## CITY OF FITCHBURG

### NOTICE PLAN COMMISSION July 21, 2015

### NOTICE PLAN COMMISSION July 21, 2015

Schematic Design Phase:  
This drawing indicates the  
scale and relationship of  
the project components.  
This drawing is not for  
construction.

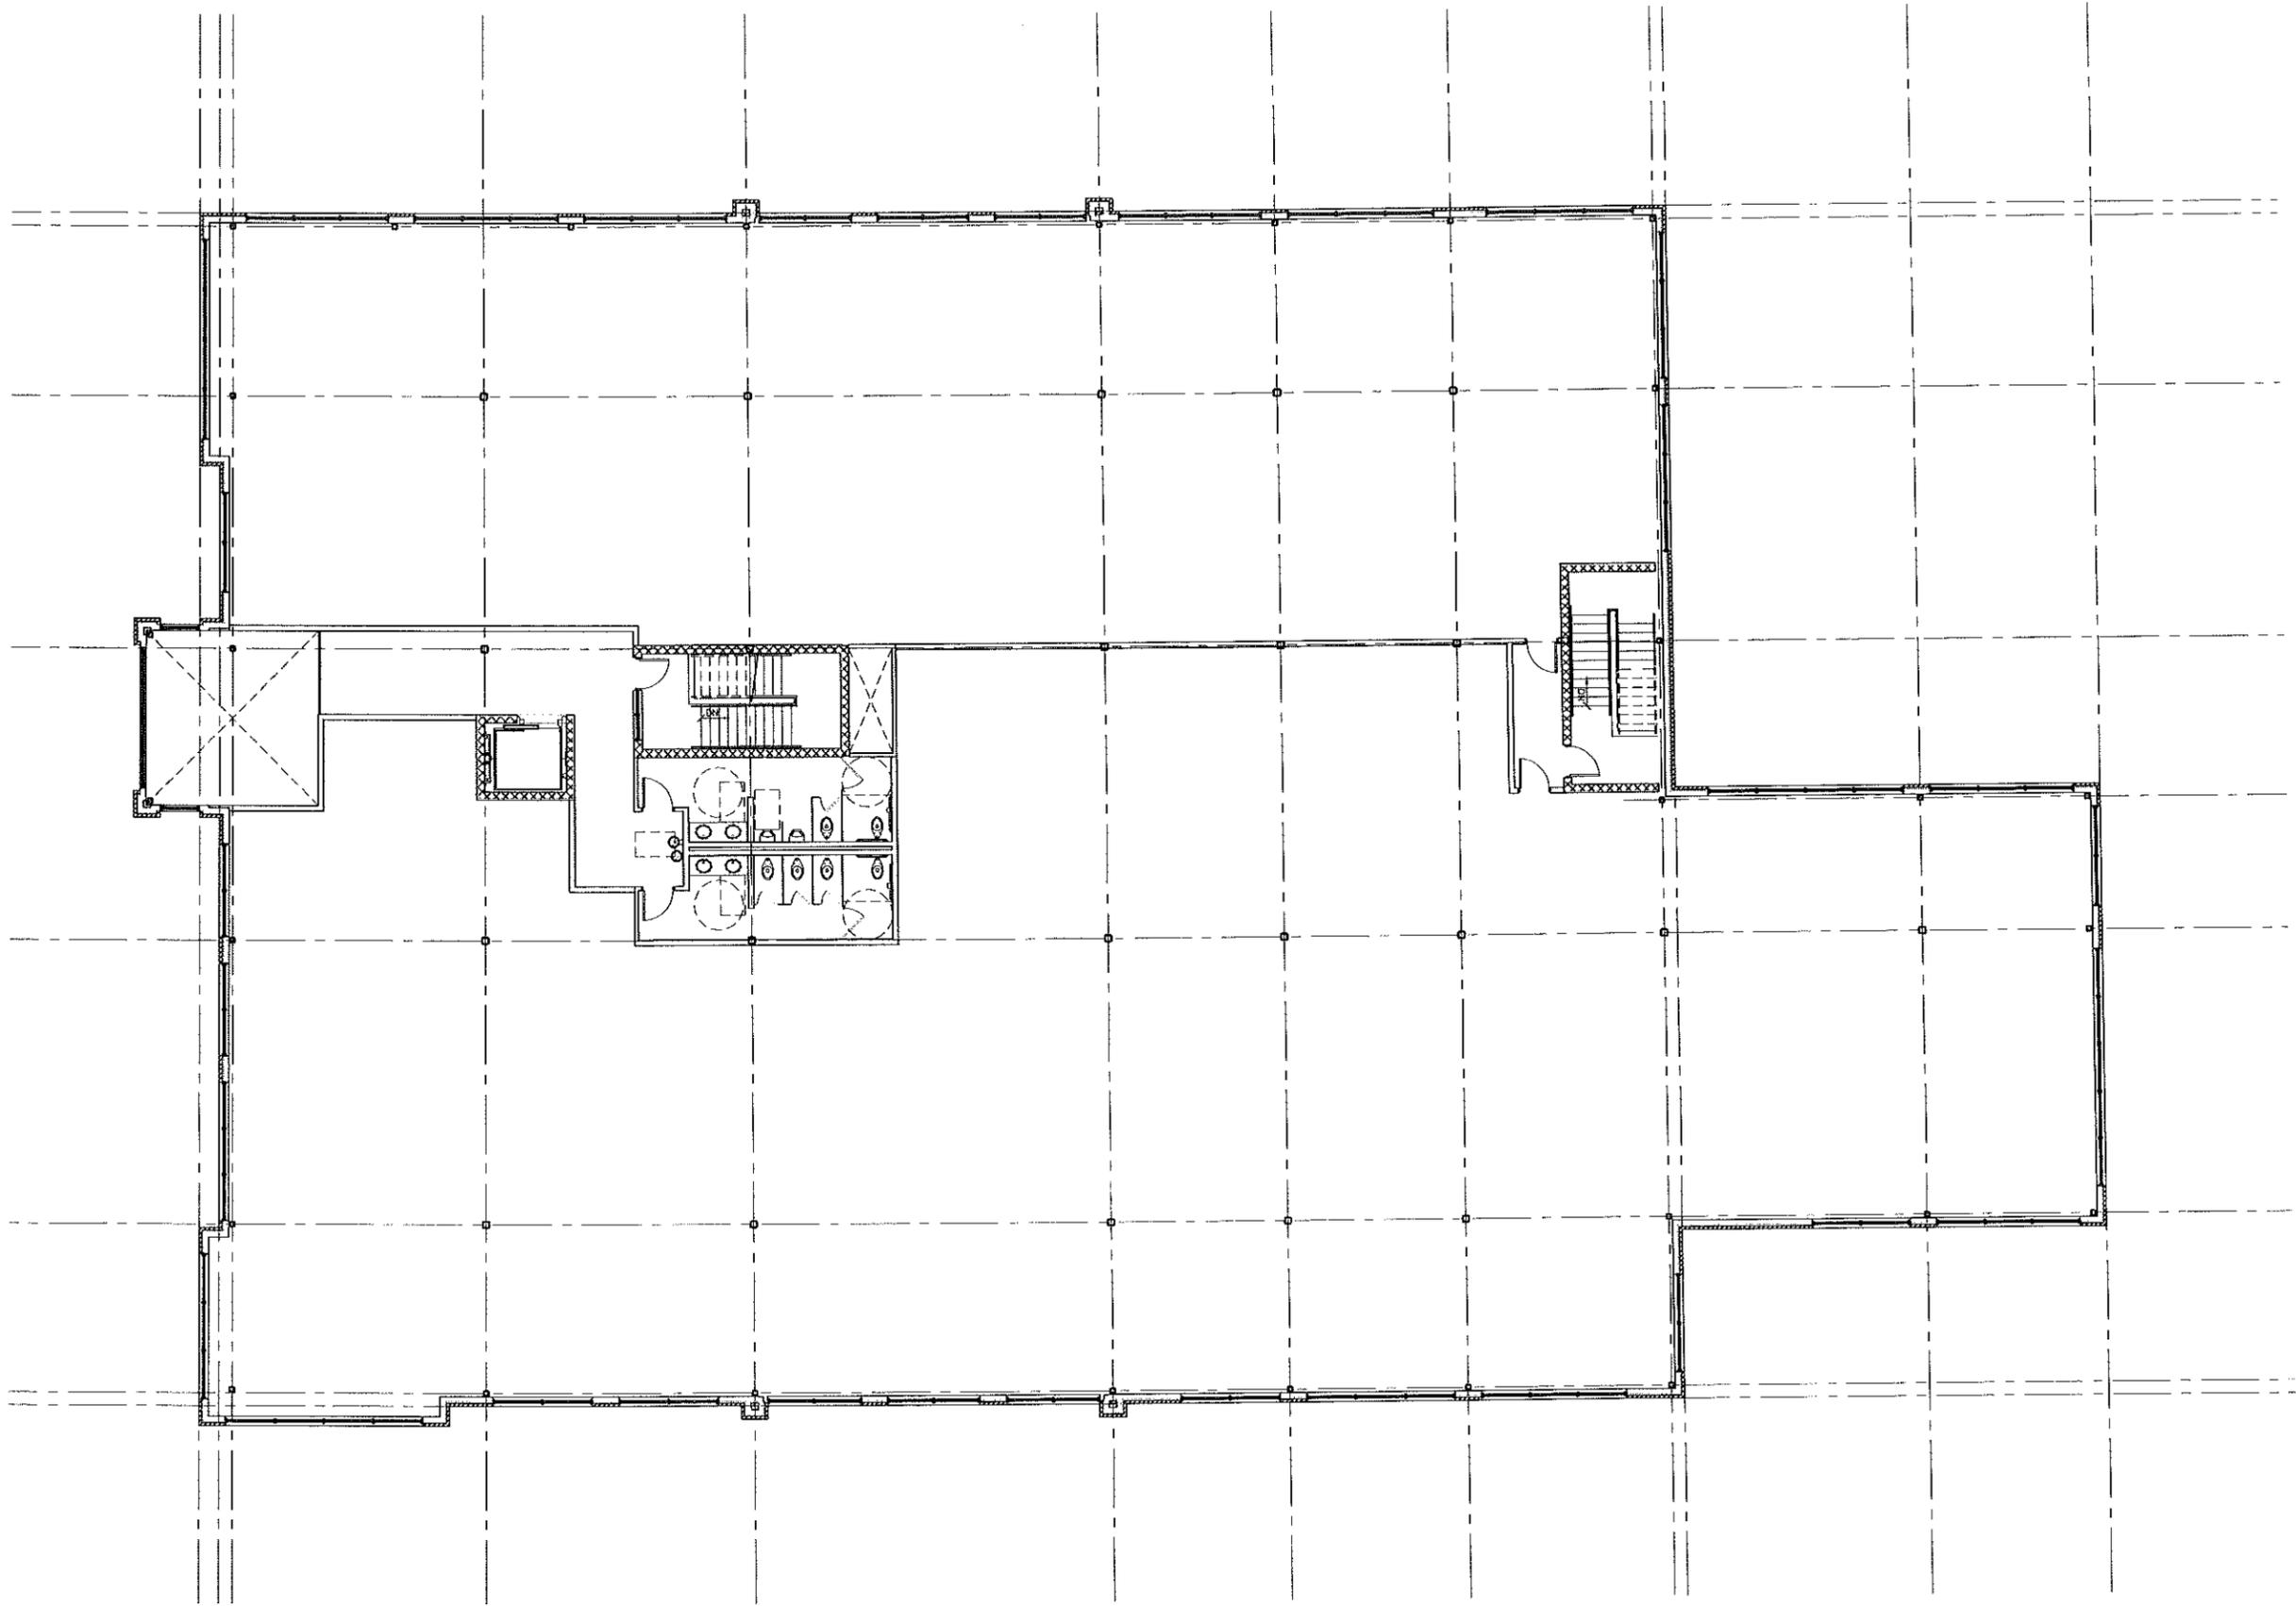
1. Sheet C-1.0 in the site information block has the building total square feet at 20067. Sheet A100 has building footprint at that number. Sheet C-1.0 appears incorrect so please provide the actual total sq ft of the building not just the footprint.

- a. The property lines shown on the plans reflect the removal of all land being turned over to the DOT.
4. Sheet C-1.0 site information block has building at three stories, when it is two, please correct.
